Product Change Notification – PCN # PCN000525.

Subject:
Replacing CPLD and fiber optic transceiver's chip for the ICF-1150 Series. Adding DIP switch to fix the baud-rate and data format for RS-485 communication.

ICF-1150 v1.1.1 top view (w/o S3 DIP switch)	ICF-1150 v1.2.0 top view (with S3 DIP switch)

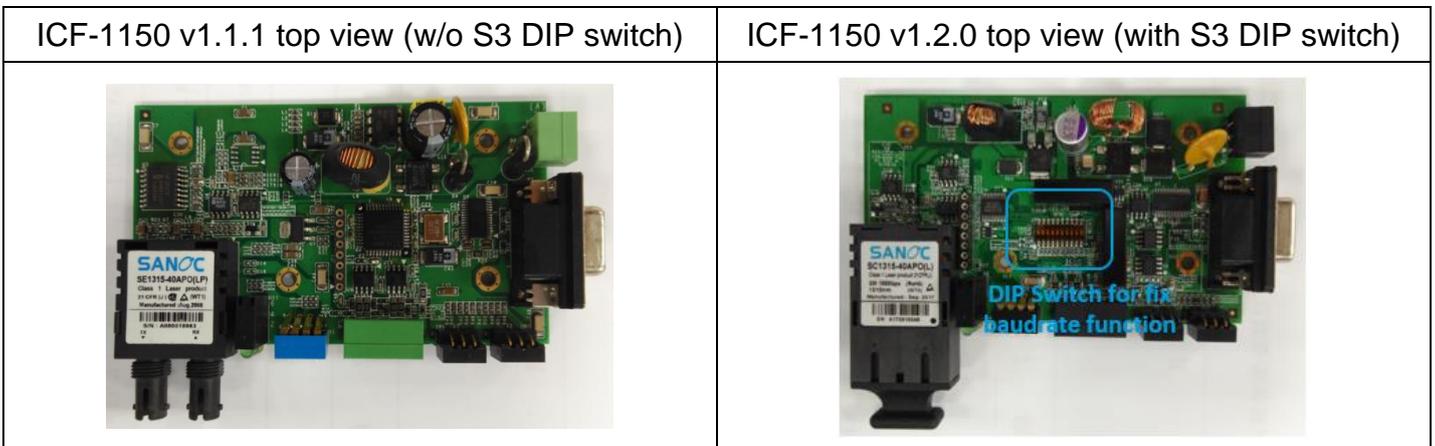
The ICF-1150 add S3 DIP Switch and the DIP switch is located inside the ICF-1150. When the ICF-1150 is in RS-485 mode, use this DIP switch to configure RS-485 data direction control, data format, and baudrate.
